SERVICE INFORMATION NO. SI D4-110

GARMIN – Service Bulletin No. 0823 Rev. B
ATA-Code: 34-00

**** MANDATORY ****
SERVICE BULLETIN

SUBJECT: GDU 104X CRS/BARO Knob Interference

Figure 1

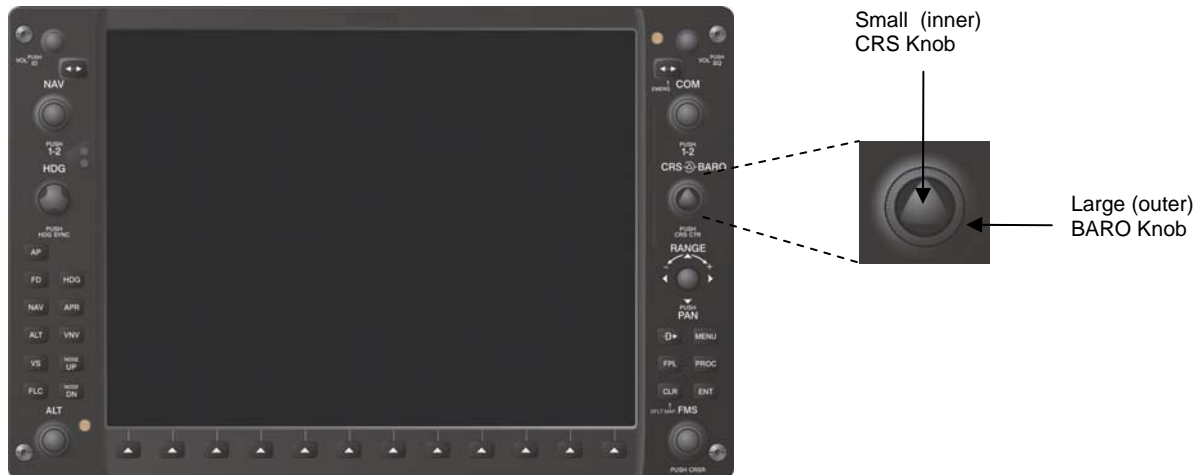
Garmin has identified an issue, whereby the large (outer) BARO knob and the small (inner) CRS knob may interfere with each other.

1. Apply power to the G1000/G900X/G950.
2. Press the CDI softkey on the Primary Flight Display(s) (PFD) to enter VOR mode on the HSI.
3. Rotate the large (outer) BARO knob (refer to Figure 1) a minimum of three complete revolutions in each direction while monitoring the Horizontal Situation Indicator/Digital Course Indicator (refer to Figure 3) on the PFD. If a change in the Horizontal Situation Indicator/Digital Course Indicator is produced while turning the BARO knob proceed to the Modification Instructions.

4. Rotate the small (inner) CRS knob (refer to Figure 1) a minimum of three complete revolutions in each direction while monitoring the Barometric Altimeter Setting (refer to Figure 3) on the PFD. If a change in the Barometric Altimeter Setting is produced while turning the CRS knob proceed to the Modification Instructions.
5. Repeat Steps 3 and 4 for each affected GDU.

If CRS/BARO Knob interference is confirmed, perform the steps below to replace the CRS/BARO Knob. New knobs can be obtained through a Garmin Service Center or Aircraft OEM under Garmin part number K00-00446-00.

Figure 4

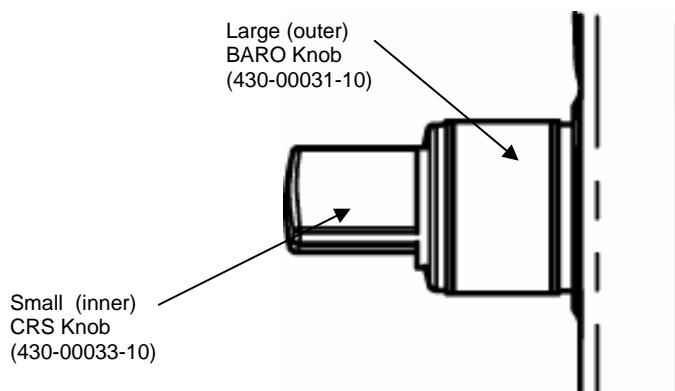
5. Grasp the large (outer) BARO knob (insuring proper orientation) and place it over the shaft.
6. Align the flat side of the knob insert with the flat side of the shaft.
7. Press down firmly to ensure knob is completely seated, refer to Figure 4.
8. Grasp the small (inner) CRS knob (insuring proper orientation) and place it over the shaft.
9. Align the flat side of the knob insert with the flat side of the shaft.
10. Press down firmly to ensure knob is completely seated, refer to Figure 4.
11. Perform the CRS/BARO Knob Interference Test (contained in the TESTING PROCEDURE section) again to confirm there is no interference.
12. Accomplish aircraft logbook entry to return aircraft to service in compliance with this service bulletin.
